Product Change Notification

Date Issued :	March 07, 2022	PCN Number :	511632
Reason for Change :	Change Supplier		
Description of Change :	This letter is to inform you that the following PCB part numbers will be using TU872LK PCB Material. The component supplier of Molex, Nisdor is encountering shortage of PCB supply of Isola FR406 which was originally used for IPass.		
Reason for Short Notice :	Special Request		
Assessment of Change :	Reliability Test Report/s		
Planned Implementation Date :	March 31, 2022		
Sample Availability Date:	March 21, 2022		
Internal Molex Qualification Date :	March 11, 2022		
Last date to request Samples by Customer :	March 21, 2022		
Traceability Code Markings / Date :	Date code

Before Picture

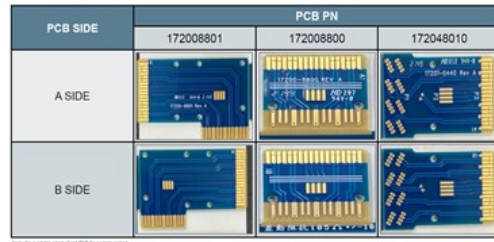
- The component supplier of Molex, Nisdor is encountering shortage of PCB supply of Isola FR406 which was originally used for IPass.
- Sample PCB:

- The following PCB part numbers will be using TU872LK PCB Material. The component supplier of Molex, Nisdrom is encountering shortage of PCB supply of Isola FR406 which was originally used for IPass.
- Product Impact
 - No impact to fit, form or function
- Samples of the affected finish goods will be provided upon request.

1. No changes on PCB design & solder mask color.
2. PCB board became lighter in color (old PCB is dark brown).
